Product Change Notification / CADA-20GQNA115

CCB 4827 Initial Notice: Qualification of MTAI as a new assembly site for selected LAN925xx and LAN9353 device families available in 64L QFN (9x9x0.9mm) package.

PCN #: CADA-20GQNA115

CCB 4827
Pre and Post Change Summary
PCN #: CADA-20GQNA115

ASE

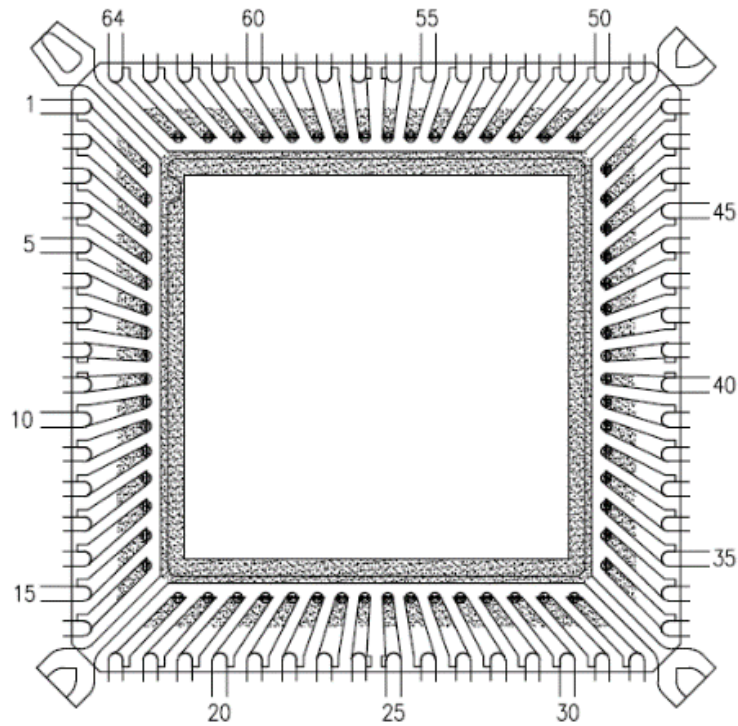
Lead frame Paddle Size

287x287mils

MTAI

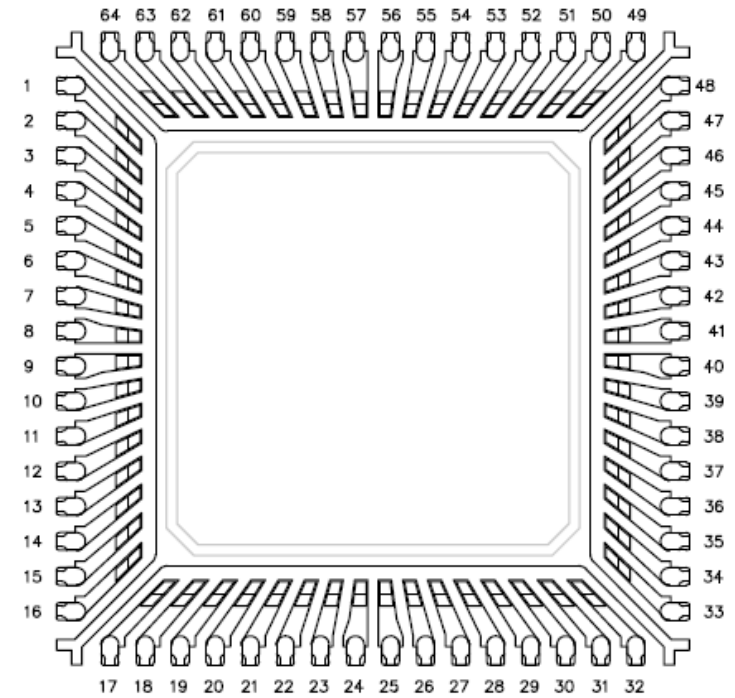
Lead frame Paddle Size

244 x 244mils
